IEEE802.3bt 4 Pair PoE Cost Comparison Redux

H. Stewart – Linear Technology

Goal of this Presentation

“Markup” Approach

PSE Breakout: Controller IC Cost Impact External FET Solution

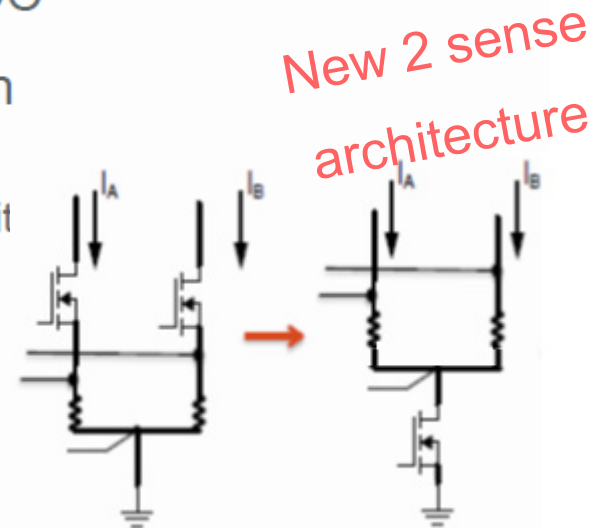
- 1 Power Channel must support high accuracy ADC
 - ~~2x dynamic range/Higher SNR results in silicon cost increase~~
 - A larger dynamic range puts more stress on analog circuit design to meet accuracy requirements.
 - Could also require more complex digital circuitry.
 - Makes it more difficult to implement on low-cost mixed signal process¹.
- 2-Power Channel
 - Requires two "AT" chip ports per RJ45

Solution	Cost Increase over 30W AT		Delta Between 1- and 2-Power Channel
	2-Power Channel	1-Power Channel	
External FET	2x	1.4x 1.2x	-30% -40% (aka +67%)

PSE Breakout: Port ^{External}FET Component Cost Impact

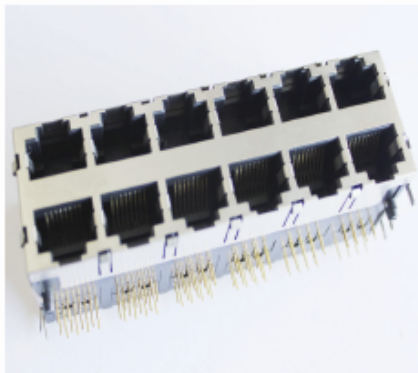
- FET Choice is controlled by two considerations
 - Thermal Dissipation during normal operation
 - SOA (Safe Operating Area)
- Same power dissipation for 2 Power Channel and 1 Power channel assumed

- Current per FET = $I_{port}/2$
- Twice number of FETs per port

- Current per FET = I_{port}
- SOA performance for 1 Power channel should support higher current compared to 2 power channel in all situations (including Short circuit)
- FET die Size of 1 power channel = 2 X FET die size of 2 power channel → Cost Impact

1.25x

-40%

Field data supports
1.25x multiple

PSE Breakout: Magnetics/Jack Cost Impact

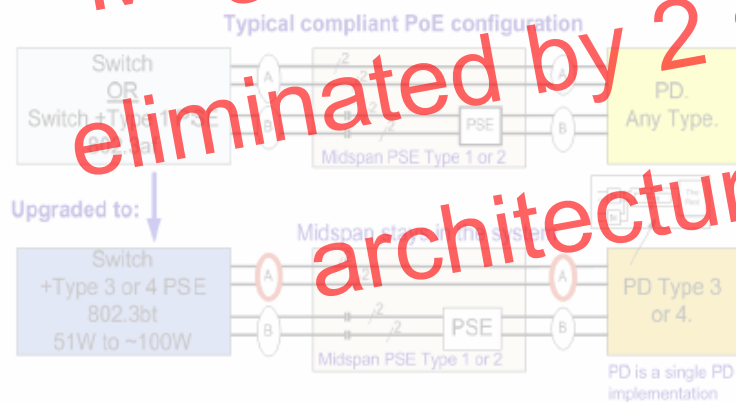
- Has no independent control over each of the 2pair
- Worst case current per 2 pair magnetics = I_{port} (refer to picture below)
- To avoid damage, bigger Magnetics needed to handle higher current → Cost Increase

MagJack argument eliminated by 2 sense architecture

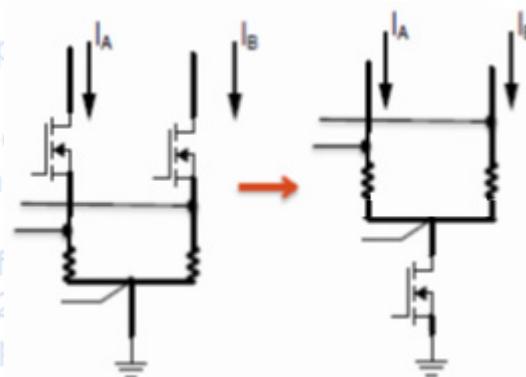
When there is a 2-pair span connected to

- If end span wins then
- 1 power channel on one 2-pair.
- For example, if provided over 2 Magjack as op

PSE Breakout: PCB Cost Impact

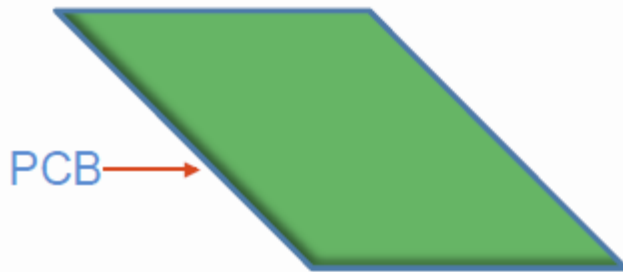
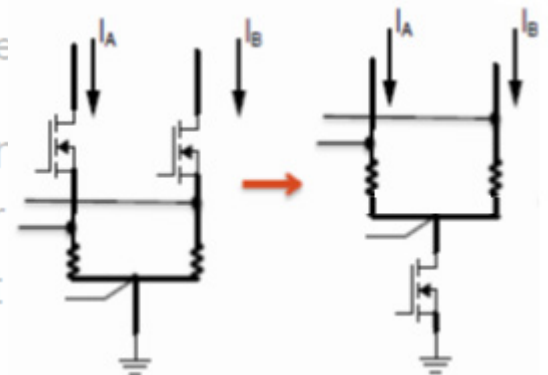
- Thermal Dissipation needs drive increased cost

- Using the 1-power channel approach instead of the 2-power channel approach introduces additional dissipation

- 1-Power channel has 2X dissipation compared to 2-Power channel

- Since the R_{sense} choices are same between 2-Power and 1-Power channels, the 1-Power channel provides accuracy

Heat argument
eliminated by 2 sense
architecture
